Office Action Summary

10/724,890

DETAILED ACTION

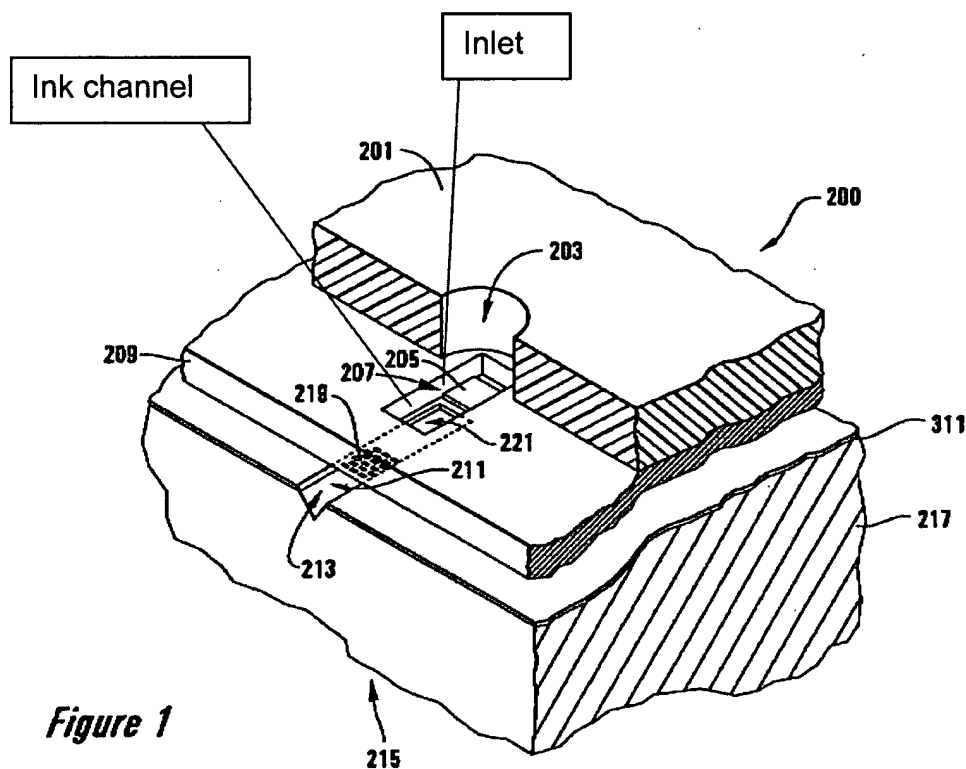
With respect to claim 1, Chee teaches:

- A silicon substrate (217)[see col. 4:42] having a plurality of heaters (205) and a main ink supply channel (215) that is connected to a cartridge (col. 2:58).
- A first barrier layer (209) has a plurality of firing chambers (207) at positions corresponding to the heaters and a plurality of ink channels that

are connected to the firing chambers and the main ink supply channel by inlets, as shown above.

- A second barrier layer (311) having a plurality of slots (213) extending from the main ink channel to the inlets of the ink channel. As can be seen in Fig. 1, the heater is located on the second barrier layer, thus the second barrier layer covers the bottom of the ink chamber.
- A nozzle plate (201) covers the first and second barrier layers and has a plurality of nozzles (203).
- The first barrier layer is located between the nozzle plate and the second barrier layer.

With respect to claim 4, the second barrier layer has a plurality of holes (219) corresponding to the nozzles.
